BCA ASSESSMENT REPORT
Concept Design

PROJECT:
Northside West - Mental Health Care Facility
Stage 2

Date: 20 October 2021

**C3.3**

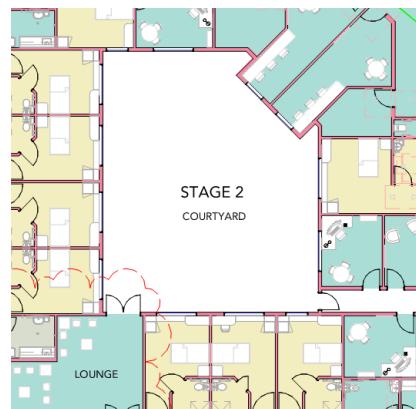
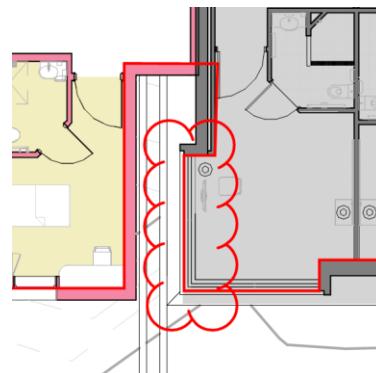
Separation of Different Fire Compartments: Exposure of external walls and associated openings in different fire compartments is expected to occur – subject to confirmation of fire compartmentation of the building

Based on a high-level review of the compartmentation plan sketches we note that there will be exposure between compartments in a number of areas.

Where external walls of adjacent fire compartments cannot be protected with FRL 60/60/60 construction and glazed openings drenched externally, they will be required to be considered under a fire engineered performance solution.

The developed design with the locations of firewalls, within patient care areas, will need to be reviewed to consider non-compliance with C3.3 – relevant to the internal courtyard connecting Three (3) Storeys.

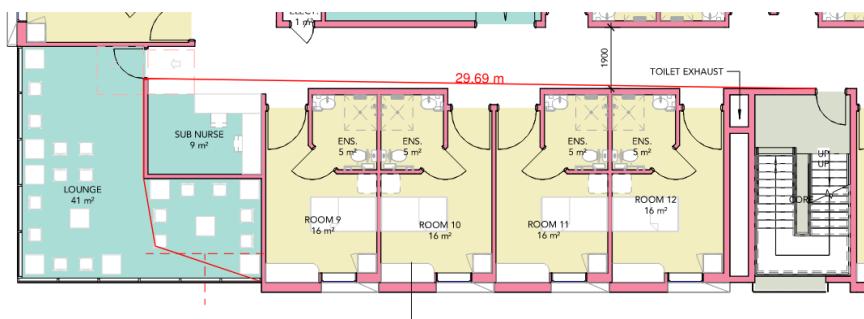
D1.3 Where fire-isolated stairways and ramps: Every stairway and ramp in a class 9a building must be fire isolated where it connects passes through or by more than two consecutive storeys.

As the building has a rise in storeys of more than two (2) all of the stairways serving the building are required to be constructed as fire isolated stairways and/or external stairs in lieu - refer to D1.8 later in this report.

Details to be provided to BM+G for review and comment accordingly.

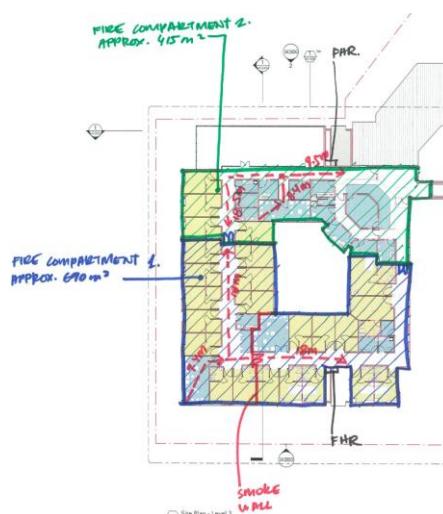
The travel distance to closest exits is currently <30m – the installation of furniture or alteration to the schematic design in the lounge, and courtyard areas, may increase travel distances to greater than 30m this is to be reviewed as part of ongoing design stages.

The provision of horizontal exits (*within FRL 120/120/120 combined fire and smoke walls*) will be required to bring travel distances down to acceptable levels – as shown in provided fire compartmentation sketch below. To be subject to further review as part of future design stages.

A final compartmentation plan will need to be provided in order to complete a travel distance assessment insufficient information is provided to confirm travel distances.

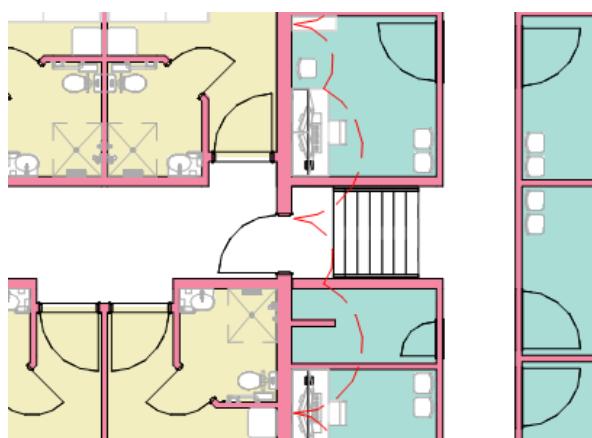
The current documentation does not provide sufficient details to show compliance.

Landing areas must be sufficient to provided room for a stretcher, as prescribed in D2.14(b), the design currently has areas which insufficient information has been provided – additional information is required to show compliance can be readily achievable.

Level 1 West Wing requires re-design to provide compliance with the landing provisions and consideration for providing compliant access for people with a disability throughout the patient care areas.
